MEMORANDUM

To: Bryce Bishop, Salem Planning
From: Ben Schonberger, AICP
Date: October 17, 2022
Re: Planning 2nd Review Response (case file 22-116522-PLN)

The following memo is a response to a letter issued by Salem Planning on October 11 for the above referenced case, a housing development at 5205 Battle Creek Road SE. The table below lists responses to each item in the same order as the letter from the city.

DATE ISSUE Drawing: FIRST FLOOR AND SECOND FLOOR PLANS

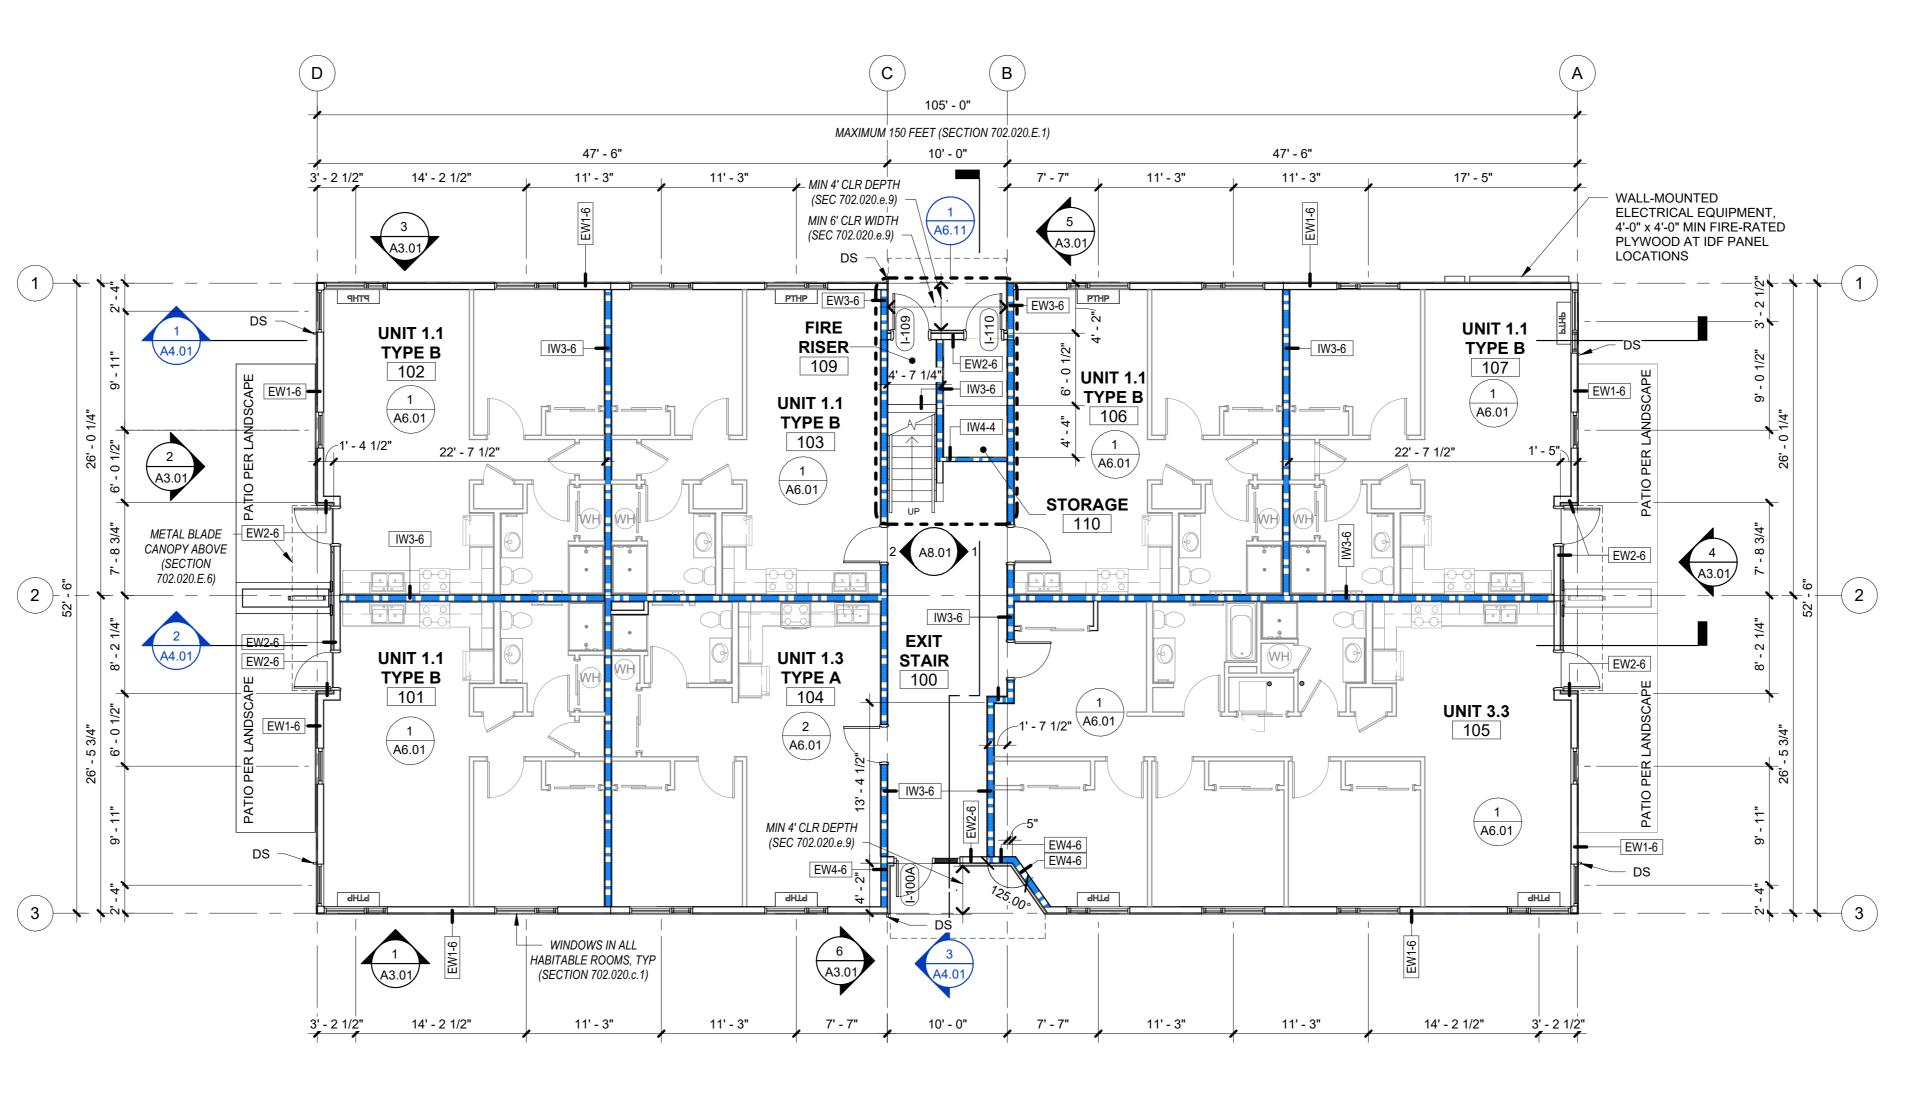
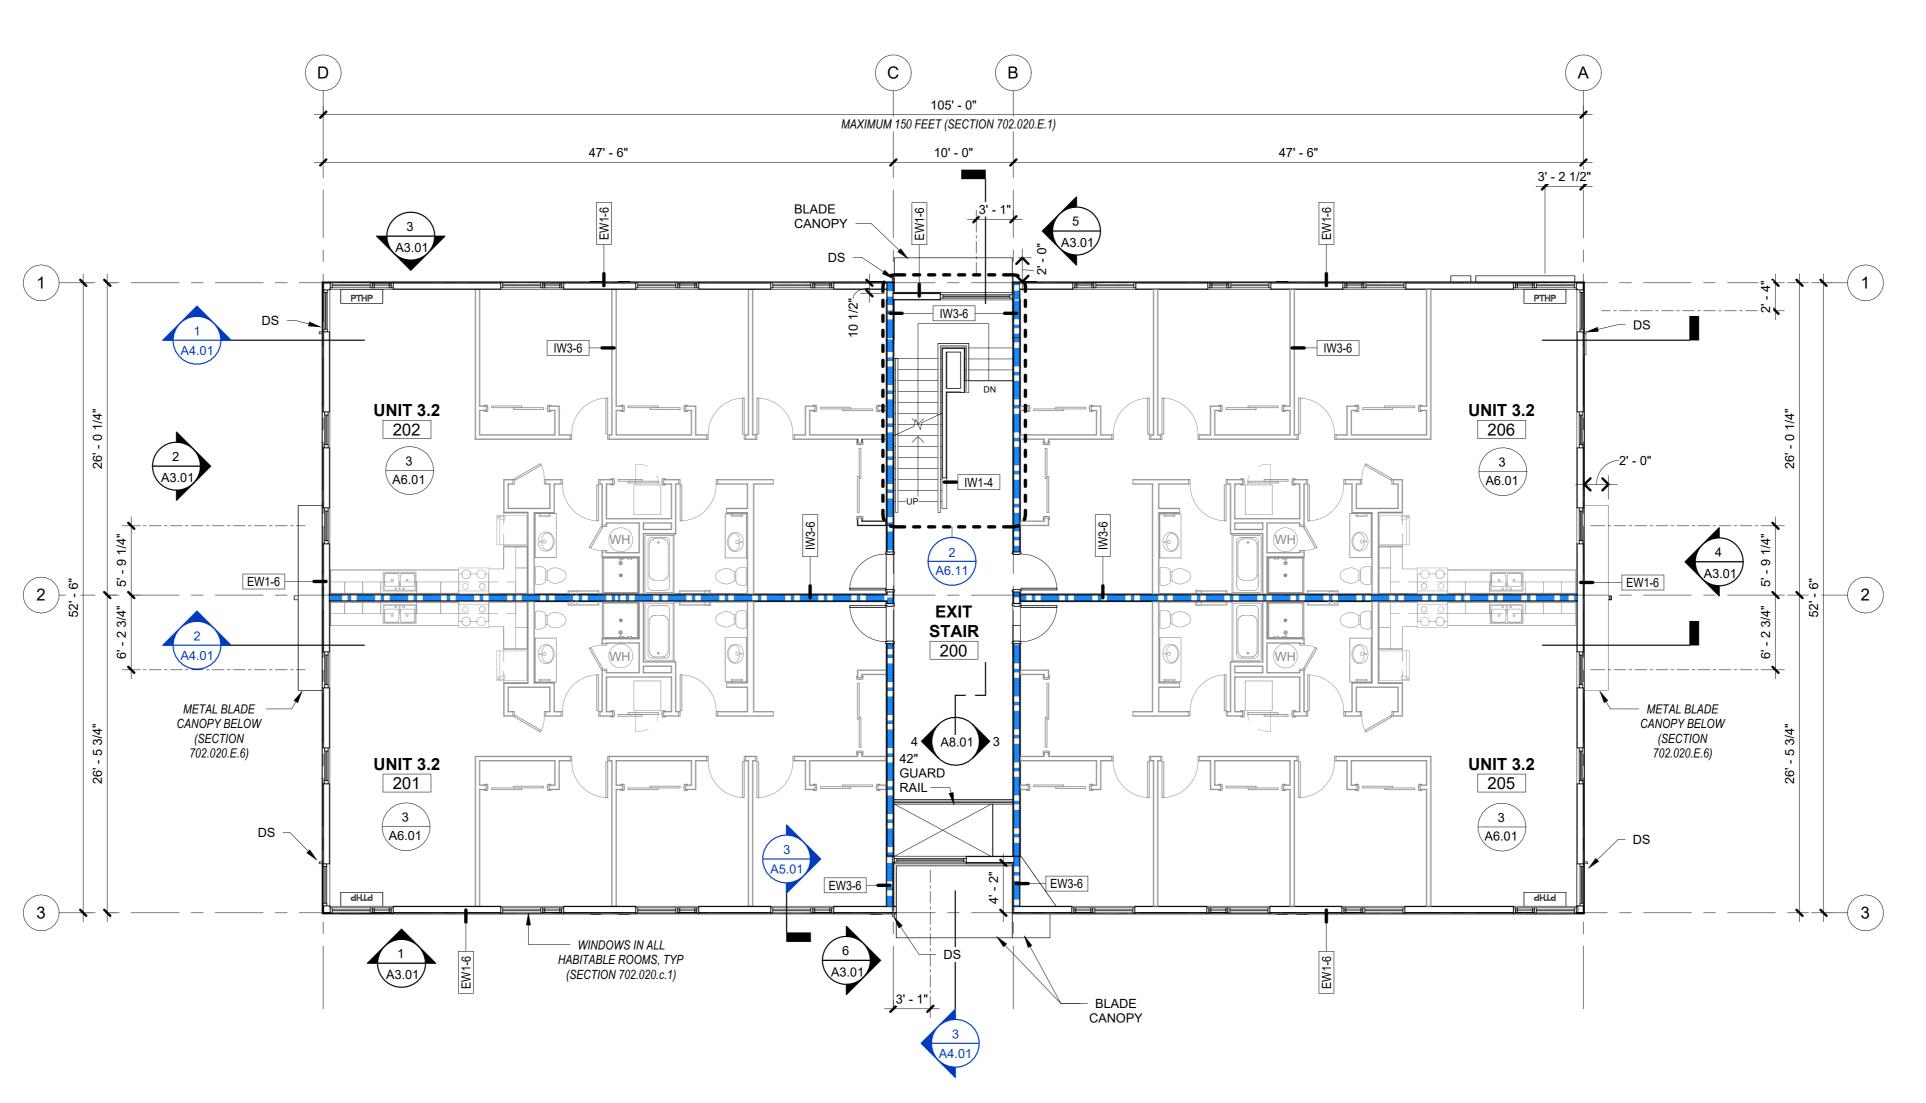
- 4. Bike Rack Access. Bike parking on the east side of Building I.3 has been reconfigured to comply with bike parking standards in Table 806-10.
- 5. Maintenance Pathway. The access to the west side of Building I.3 is in fact a maintenance pathway. The ground floor plan for the building has been revised and the plans updated to show the internal configuration of space.

In short, the second door on the west side of Building I.3 now leads into a maintenance storage room. Neither of the doors have access to other internal space in the building (*i.e.*, hallway or dwelling units). They are only accessible to maintenance workers or emergency services personnel, and are therefore very infrequently used. The path to these doors is thus a maintenance pathway that does not require a full five-foot pedestrian path. A revised floor plan drawing is attached to this memo and will be part of revised set submitted to Salem for building permits.
